PCI-SIG ENGINEERING CHANGE REQUEST

TITLE:	Hot Plug
DATE:	24 June 2004 [Updated 12 July 2004]
AFFECTED DOCUMENT:	PCI Express Base Specification Revision 1.0a
SPONSOR:	Mohan Kumar & David Harriman, Intel Corporation Dave Walker, Microsoft Carl Jackson, HP

Figure 7-13: Device Capabilities Register

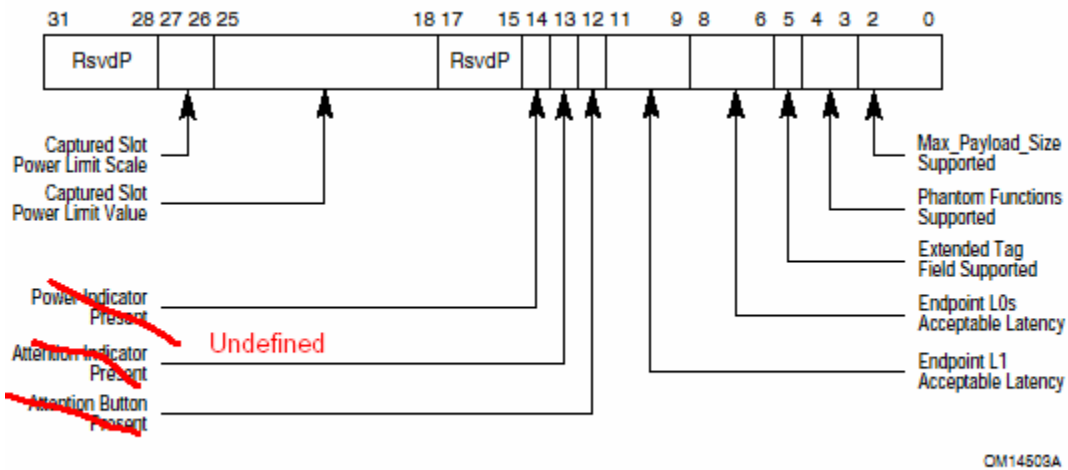
Bit Location	Register Description	Attributes
...		
12	<p>The value read from this bit is undefined. In previous versions of this specification, this bit was used to indicate that an Attention Button is implemented on the adapter and electrically controlled by the component on the adapter. System software must ignore the value read from this bit. System software is permitted to write any value to this bit. Attention Button Present—When set to 1b, this bit indicates that an Attention Button is implemented on the adapter and is electrically controlled by the component on the adapter. Attention Button press events are reported using the Attention_Button_Pressed Message.</p> <p>This bit is valid for the following PCI Express device Types:</p> <ul style="list-style-type: none"> • PCI Express Endpoint device • Legacy PCI Express Endpoint device • Upstream Port of PCI Express Switch • PCI Express to PCI/PCI-X Bridge 	RO

Bit Location	Register Description	Attributes
13	<p>The value read from this bit is undefined. In previous versions of this specification, this bit was used to indicate that an Attention Indicator is implemented on the adapter and electrically controlled by the component on the adapter. System software must ignore the value read from this bit. System software is permitted to write any value to this bit. Attention Indicator Present—When set to 1b, this bit indicates that an Attention Indicator is implemented on the adapter and is electrically controlled by the component on the adapter using the Attention_Indicator_On, Attention_Indicator_Blink, and Attention_Indicator_Off Messages.</p> <p>This bit is valid for the following PCI Express device Types:</p> <ul style="list-style-type: none"> • PCI Express Endpoint device • Legacy PCI Express Endpoint device • Upstream Port of PCI Express Switch • PCI Express to PCI/PCI-X Bridge 	RO

14	<p>The value read from this bit is undefined. In previous versions of this specification, this bit was used to indicate that a Power Indicator is implemented on the adapter and electrically controlled by the component on the adapter. System software must ignore the value read from this bit. System software is permitted to write any value to this bit. Power Indicator Present—When set to 1b, this bit indicates that a Power Indicator is implemented on the adapter and is electrically controlled by the component on the adapter using the Power_Indicator_On, Power_Indicator_Blink, and Power_Indicator_Off Messages.</p> <p>This bit is valid for the following PCI Express device Types:</p> <ul style="list-style-type: none"> • PCI Express Endpoint device • Legacy PCI Express Endpoint device • Upstream Port of PCI Express Switch • PCI Express to PCI/PCI-X Bridge 	RO
...

Figure 7-19: Slot Capabilities Register

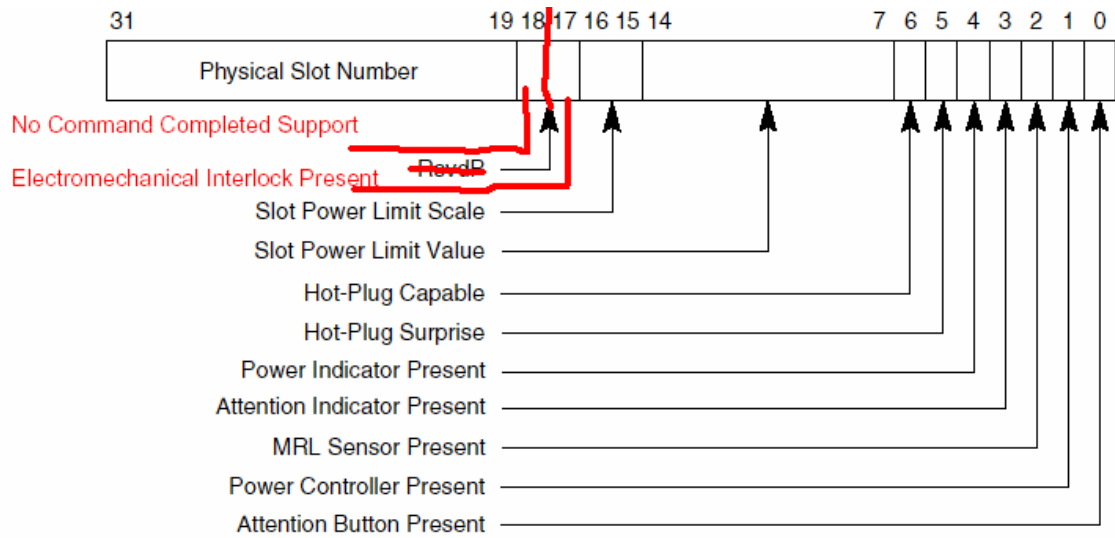
Bit Location	Register Description	Attributes
...		
17	Electromechanical Interlock Present – When set to 1b, this bit indicates that an Electromechanical Interlock is implemented on the chassis for this slot.	Hwinit
18	No Command Completed Support – When set to 1b, this bit indicates that this slot does not generate software notification when an issued command is completed by the Hot-Plug Controller. This bit is only permitted to be set to 1b if the hot-plug capable port is able to accept writes to all fields of the Slot Control register without delay between successive writes.	Hwinit
...

Figure 7-20: Slot Control Register

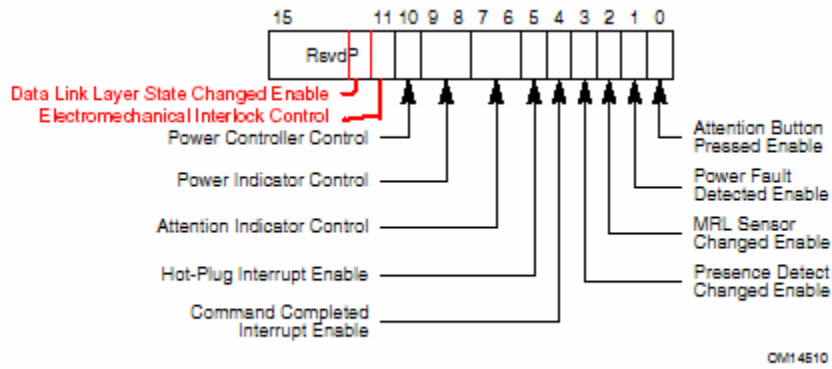
Bit Location	Register Description	Attributes
0	Attention Button Pressed Enable – When set to 1b, this bit enables software notification on an attention button pressed event. See Section 6.7.7. Software may set this bit even if the Attention Button Supported bit in the Slot Capabilities register is 0b, so that Attention_Button_Pressed messages can cause software notification. Default value of this field is 0b.	RW
...		
4	Command Completed Interrupt Enable – If Command Completed notification is supported (as indicated by No Command Completed Support field of Slot Capabilities Register), When set to 1b, this bit enables software notification when a hot-plug command is completed by the Hot-Plug Controller. Default value of this field is 0b. If Command Completed notification is not supported this bit must be hardwired to 0b.	RW
...

Bit Location	Register Description	Attributes								
7:6	<p>Attention Indicator Control – If an Attention Indicator is implemented, writes to this field set the Attention Indicator to the written state. Reads of this field must reflect the value from the latest write, even if the corresponding hot-plug command is not complete, unless software issues a write without waiting for the previous command to complete in which case the read value is undefined.</p> <p>If the indicator is electrically controlled by chassis, the indicator is controlled directly by the downstream port through implementation specific mechanisms. If the indicator is electrically controlled by the adapter, the indicator is indirectly controlled by transmission of the appropriate Attention Indicator Message (determined by the value written). Regardless of the location of the indicator, the downstream port must transmit the appropriate Attention Indicator Message.</p> <p>Defined encodings are:</p> <table> <tr> <td>00b</td> <td>Reserved</td> </tr> <tr> <td>01b</td> <td>On</td> </tr> <tr> <td>10b</td> <td>Blink</td> </tr> <tr> <td>11b</td> <td>Off</td> </tr> </table> <p>Note: The default value of this field must be one of the non-Reserved values.</p>	00b	Reserved	01b	On	10b	Blink	11b	Off	RW

00b	Reserved									
01b	On									
10b	Blink									
11b	Off									
9:8	<p>Power Indicator Control – If a Power Indicator is implemented, writes to this field set the Power Indicator to the written state. Reads of this field must reflect the value from the latest write, even if the corresponding hot-plug command is not complete, unless software issues a write without waiting for the previous command to complete in which case the read value is undefined.</p> <p>If the indicator is electrically controlled by chassis, the indicator is controlled directly by the downstream port through implementation specific mechanisms. If the indicator is electrically controlled by the adapter, the indicator is indirectly controlled by transmission of the appropriate Power Indicator Message (determined by the value written). Regardless of the location of the indicator, the downstream port must transmit the appropriate Power Indicator Message.</p> <p>Defined encodings are:</p> <table> <tr> <td>00b</td> <td>Reserved</td> </tr> <tr> <td>01b</td> <td>On</td> </tr> <tr> <td>10b</td> <td>Blink</td> </tr> <tr> <td>11b</td> <td>Off</td> </tr> </table> <p>Note: The default value of this field must be one of the non-Reserved values.</p>	00b	Reserved	01b	On	10b	Blink	11b	Off	RW

00b	Reserved									
01b	On									
10b	Blink									
11b	Off									
...										
<u>11</u>	<p>Electromechanical Interlock Control – If an <u>Electromechanical Interlock</u> is implemented, a write of 1b to this field causes the state of the interlock to toggle. A write of 0b to this field has no effect. A read to this register always returns a 0.</p>	<u>RW</u>								
<u>12</u>	<p>Data Link Layer State Changed Enable – If the <u>Data Link Layer Link Active</u> capability is implemented, when set to 1b, this field enables software notification when <u>Data Link Layer Link Active</u> field is changed</p>	<u>RW</u>

Figure 7-21: Slot Status Register

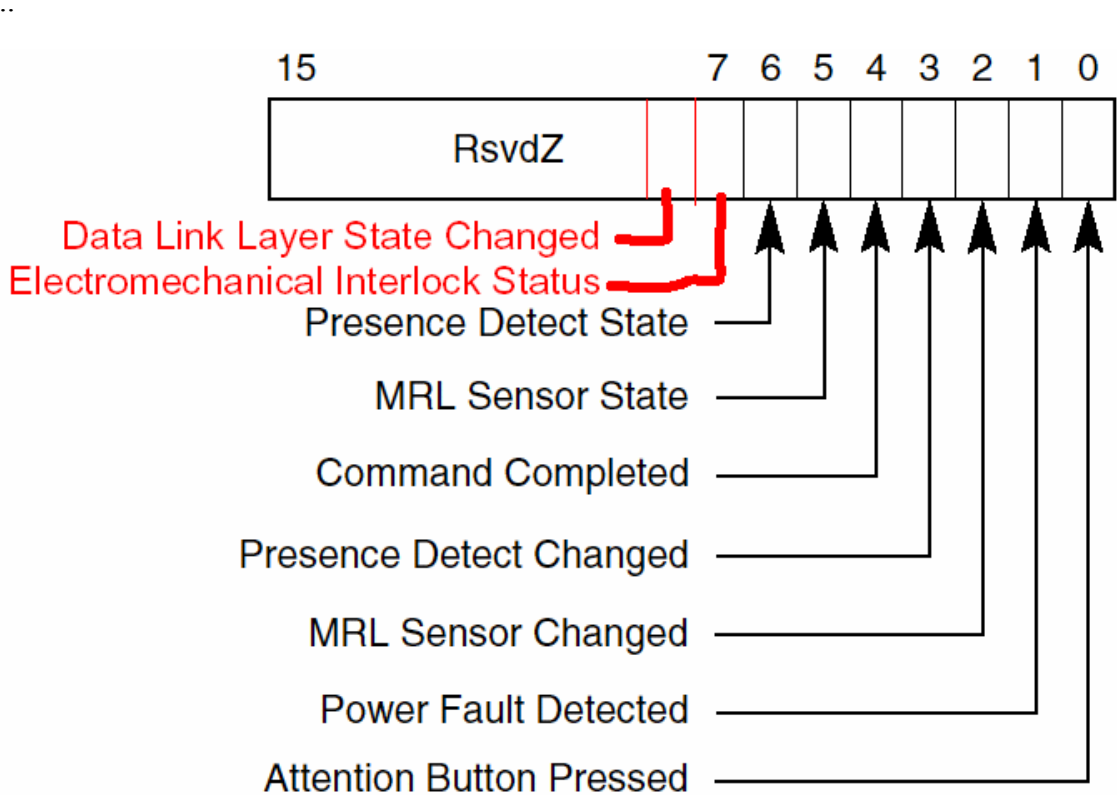
Bit Location	Register Description	Attributes
0	Attention Button Pressed – If an Attention Button is implemented, this bit is set when the attention button is pressed (either as directly detected or by the receipt of an Attention_Button_Pressed Message). If an Attention Button is not supported and the form factor does not support the Attention_Button_Pressed Message , this bit must not be set.	RW1C
...

Bit Location	Register Description	Attributes
4	<p>Command Completed – If Command Completed notification is supported (as indicated by No Command Completed Support field of Slot Capabilities Register), this bit is set when a hot-plug command has completed and the Hot-Plug Controller is ready to accept a subsequent command. The Command Completed status bit is set as an indication to host software that the Hot-Plug Controller has processed the previous command and is ready to receive the next command; it provides no guarantee that the action corresponding to the command is complete.</p> <p>If Command Completed notification is not supported, this bit must be hardwired to 0b.</p>	RW1C
...		
7	<p>Electromechanical Interlock Status – If an Electromechanical Interlock is implemented, this bit indicates the current status of the Electromechanical Interlock.</p> <p>Defined encodings are:</p> <p>0b Electromechanical Interlock Disengaged</p> <p>1b Electromechanical Interlock Engaged</p>	RO

8	<p>Data Link Layer State Changed - This bit is set when the value reported in Data Link Layer Link Active field of the Link Status register is changed</p> <p>In response to a Data Link Layer State Changed event, software must read Data Link Layer Link Active field of the Link Status register to determine if the link is active before initiating configuration cycles to the hot plugged device.</p>	RW1C
...
